Permit No. 48/1215

Subject: Permit demolishing shed
8' x 12' and constructing new
shed 16' x 20' at Highland Ave-
nue, Long Island

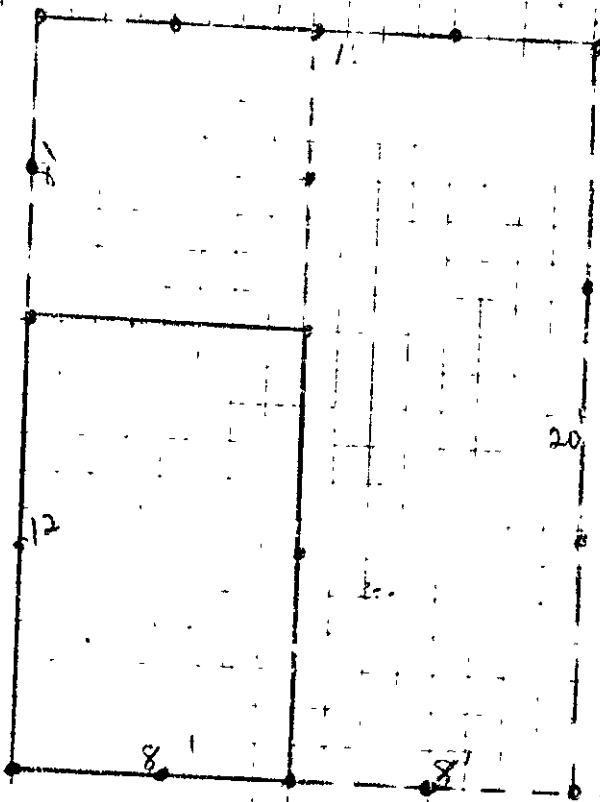
The spacing of cedar posts beneath the sills which will
carry both floor and roof loads must be no greater than 5 feet
on centers. The 4x6 sills must be placed with the 4" dimension
vertical in order to figure out.
